ADDENDUM NO. 1

Wayne High School Campus Improvements

Fort Wayne Community Schools (FWCS)

November 7, 2025

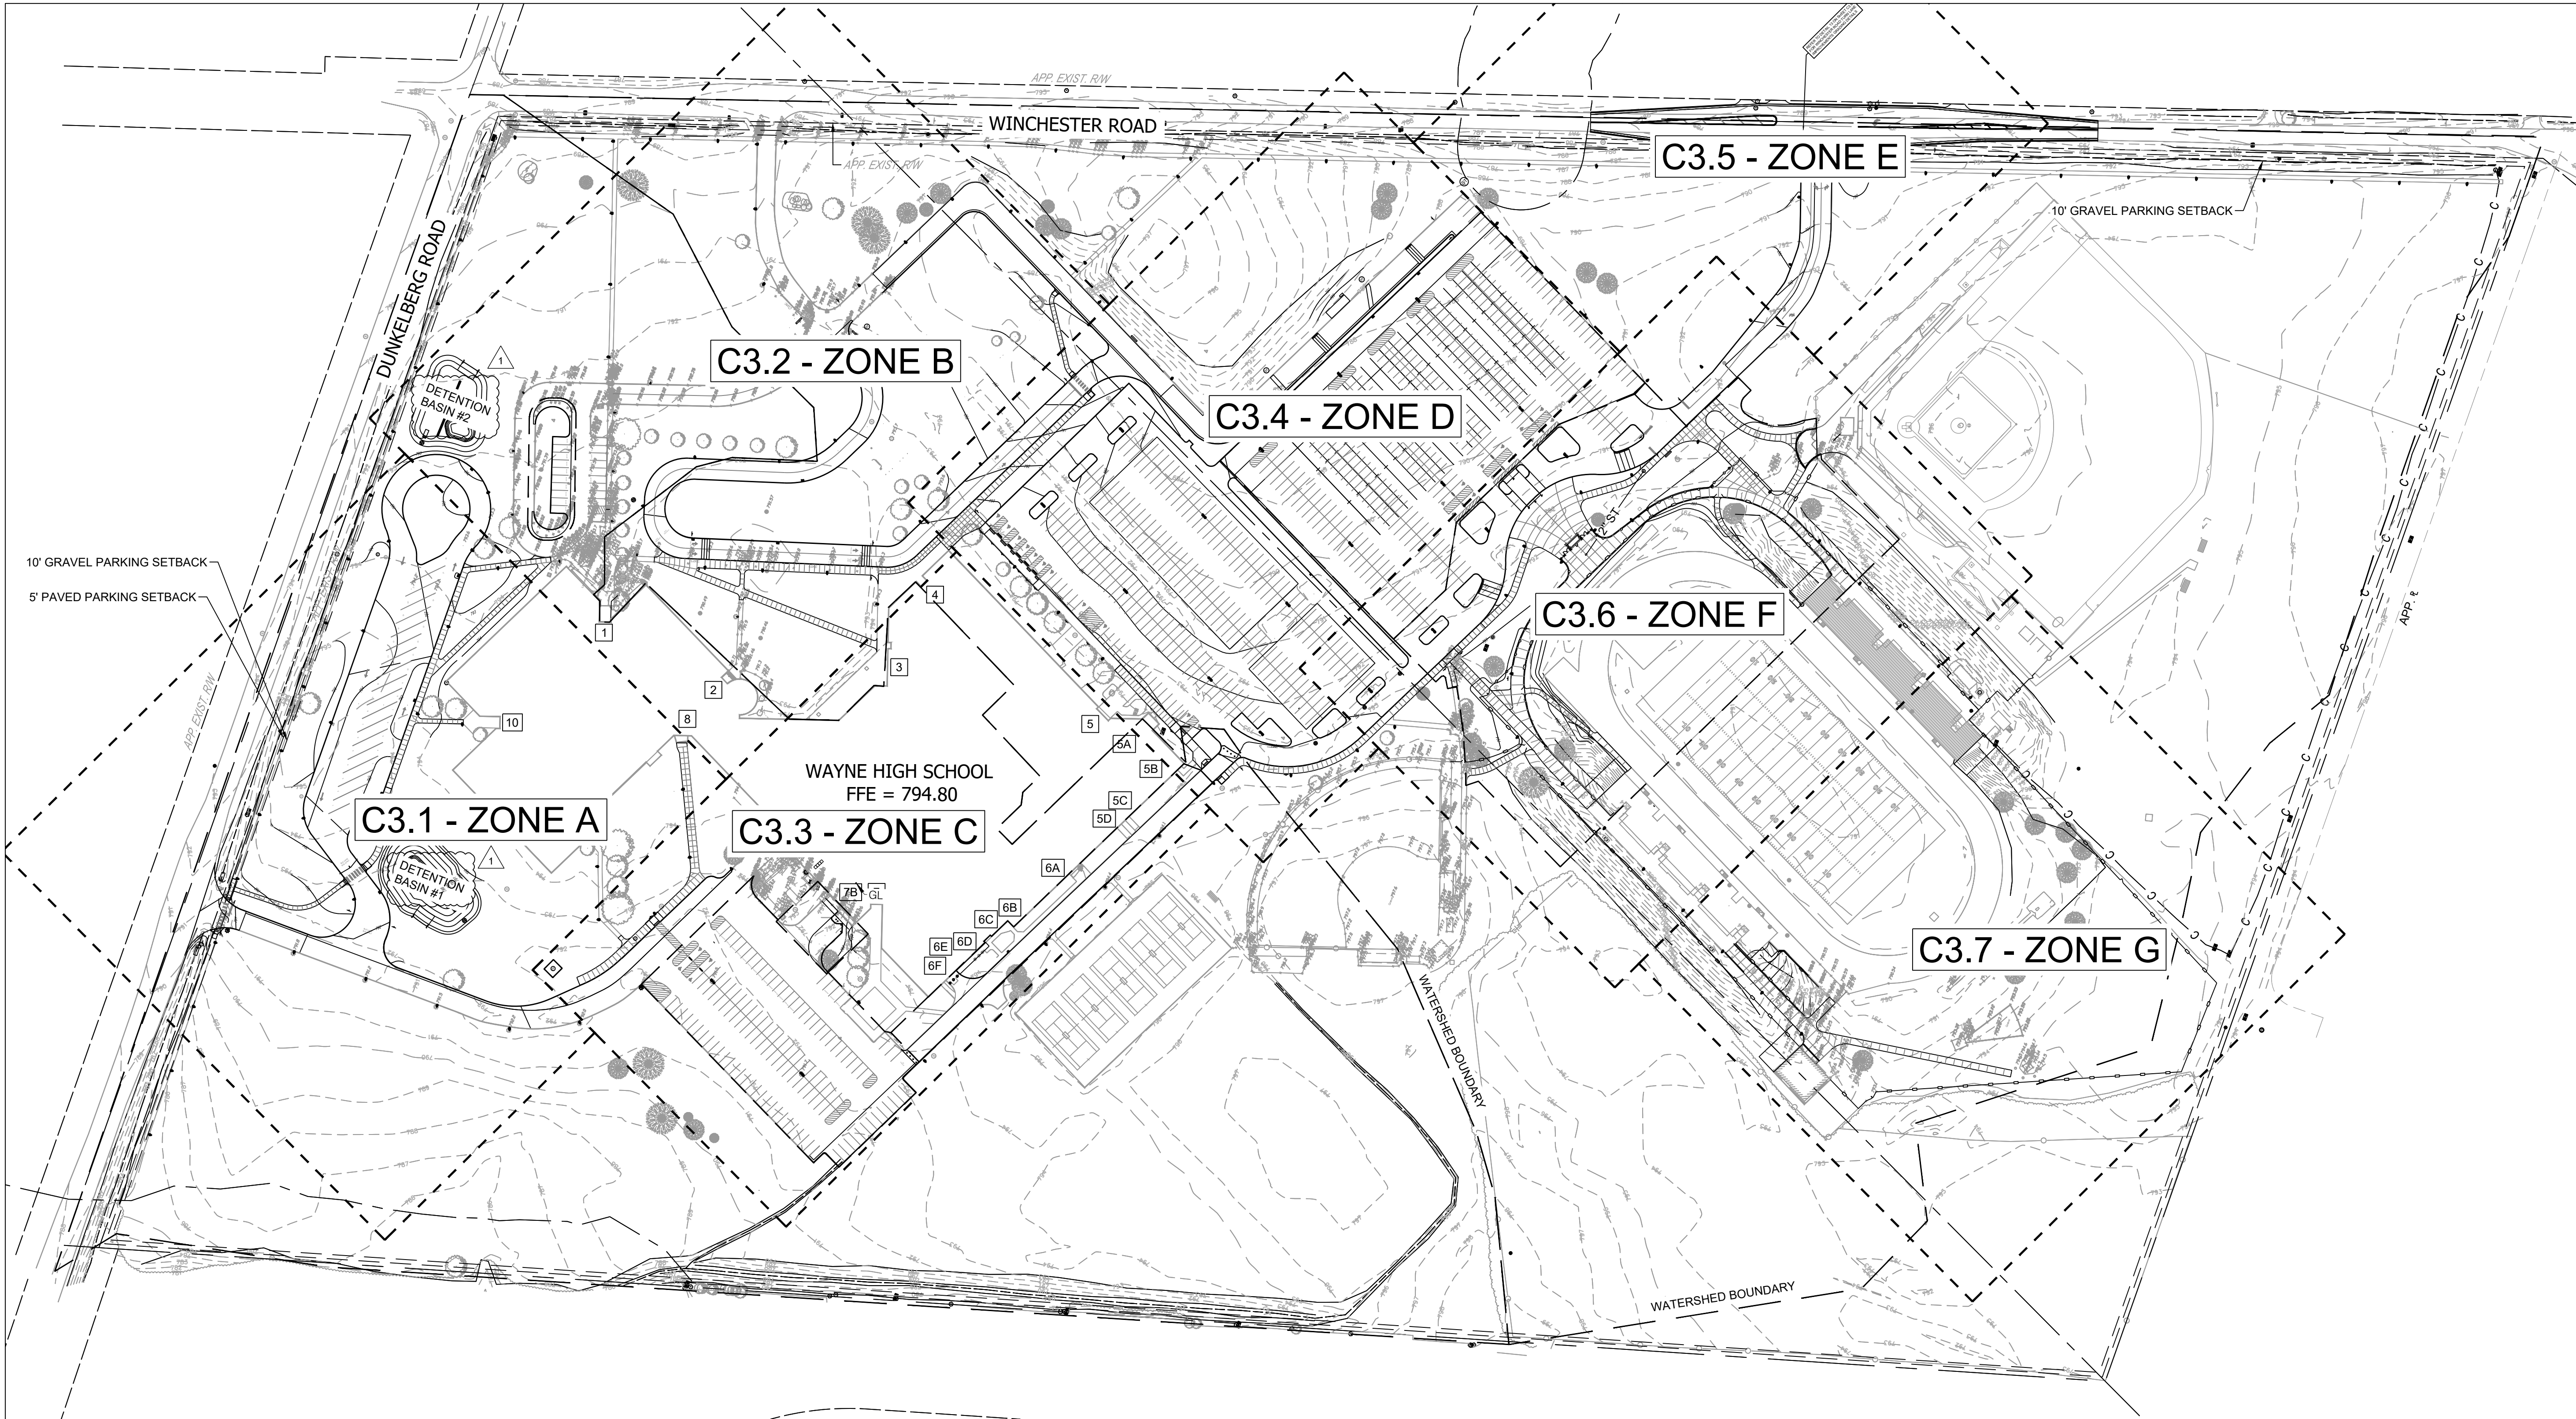
REVISED: Detention Basin Stage Volume calculation tables and Detention Basin Storage calculation tables.

REVISED: Detention Basin numbering to match Grading Plan.

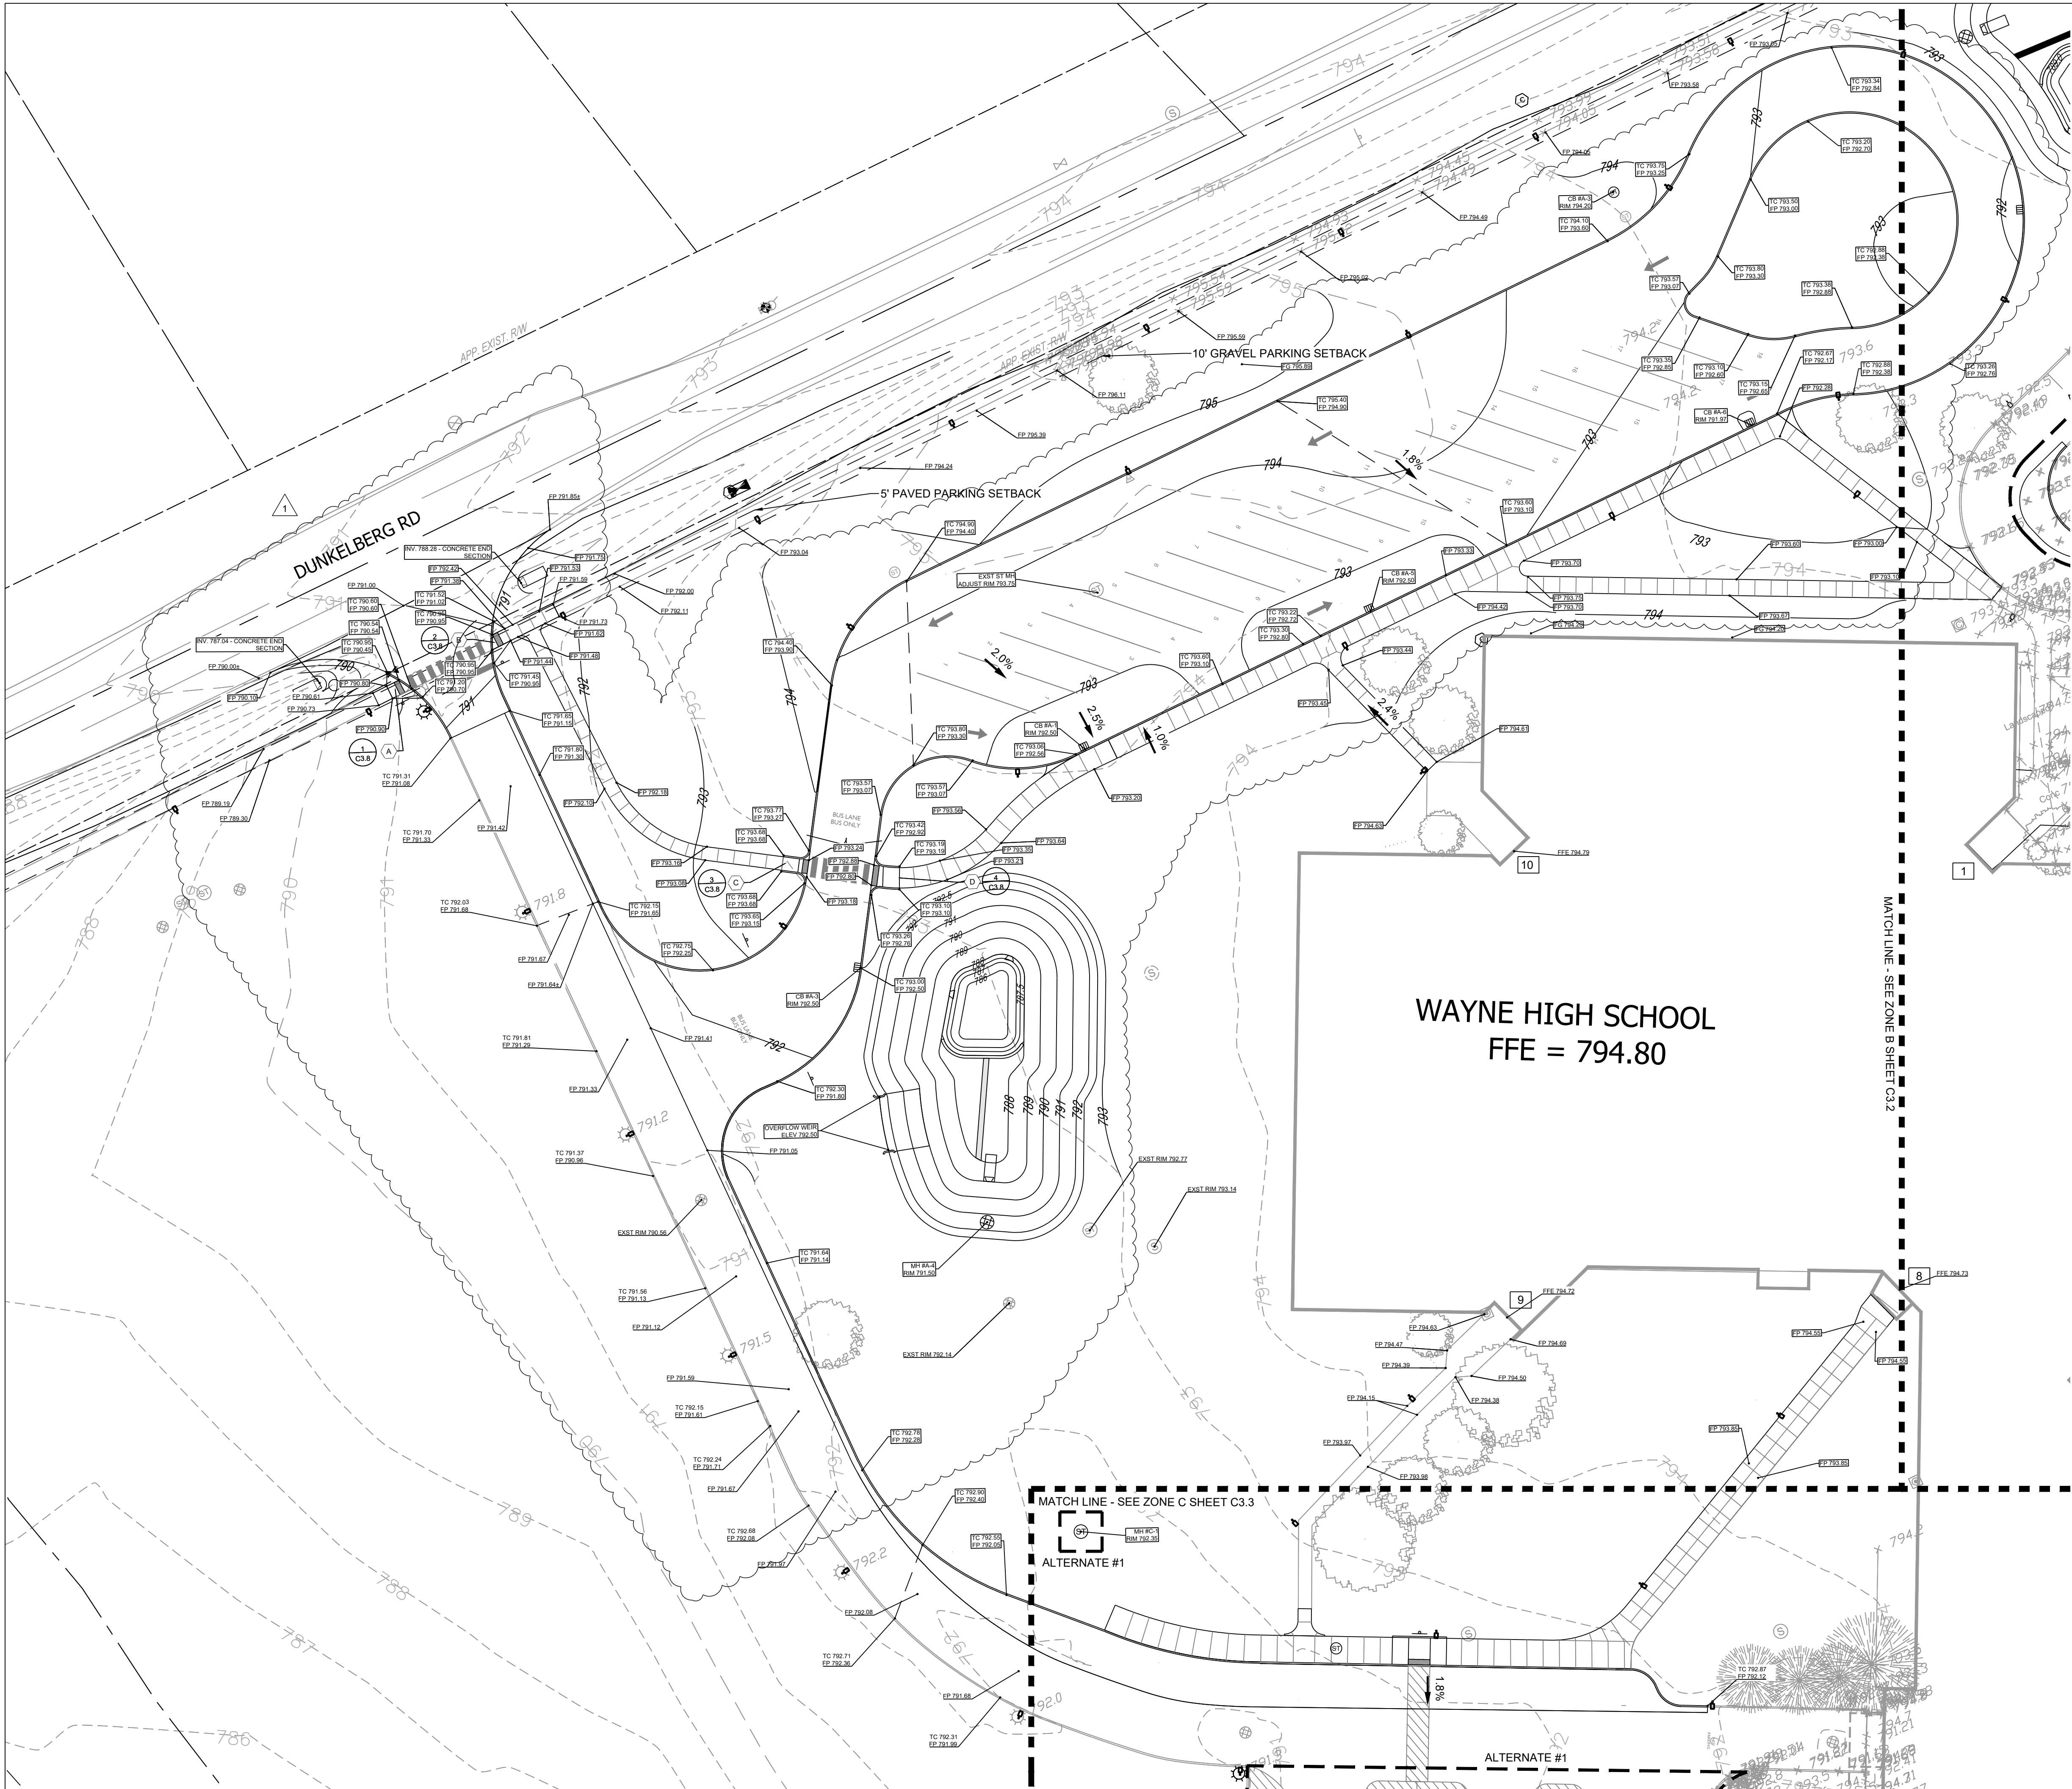
REVISED: Plan sheet grades and contours.

WAYNE HIGH SCHOOL CAMPUS IMPROVEMENTS		DESIGNED BY: BPE		DATE: NOVEMBER 7, 2025	
FORT WAYNE COMMUNITY SCHOOLS		REVIEWED BY: AC		JOB NUMBER: 2025-01487	
1200 S CLINTON STREET		DRAWN BY: BS		HORIZ. SCALE: 1" = 30'	
SITE GRADING PLAN - ZONE B		REVIEWED BY: CEE, AC		VERTICAL SCALE: N/A	
C3.2

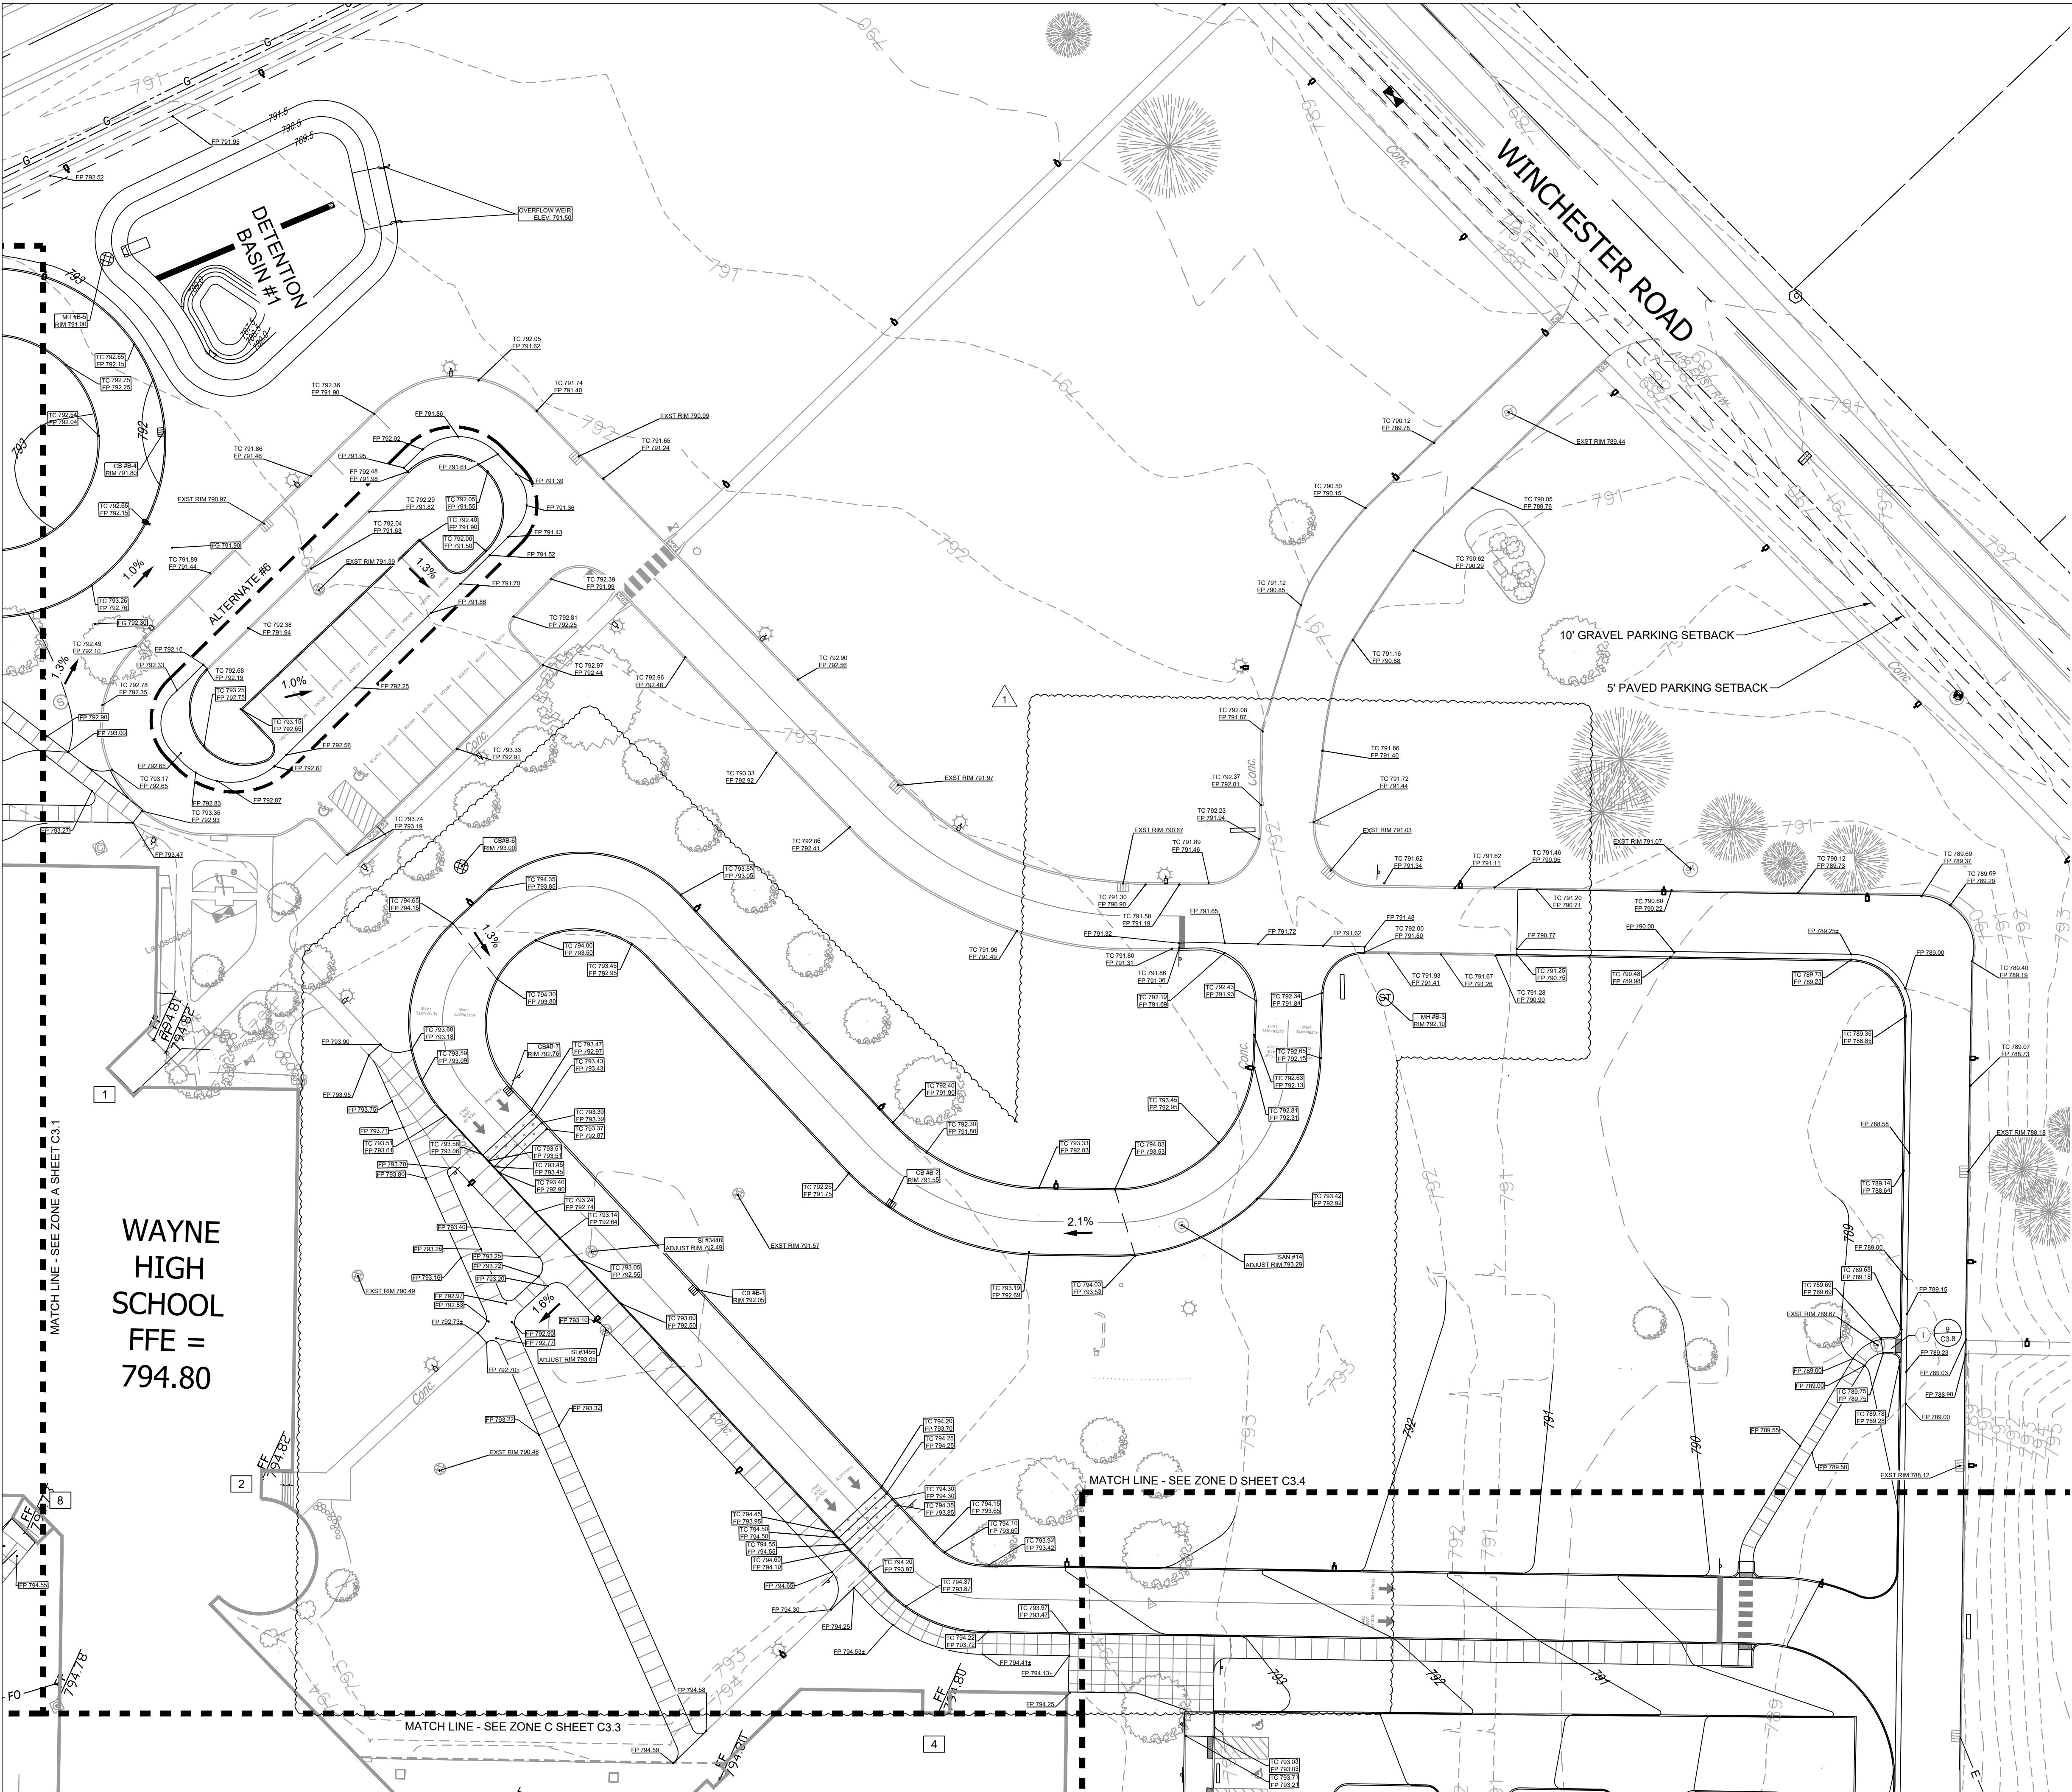
19. Plan Sheet C3.2– Site Grading Plan – Zone B
REVISED: Plan sheet grades and storm structures
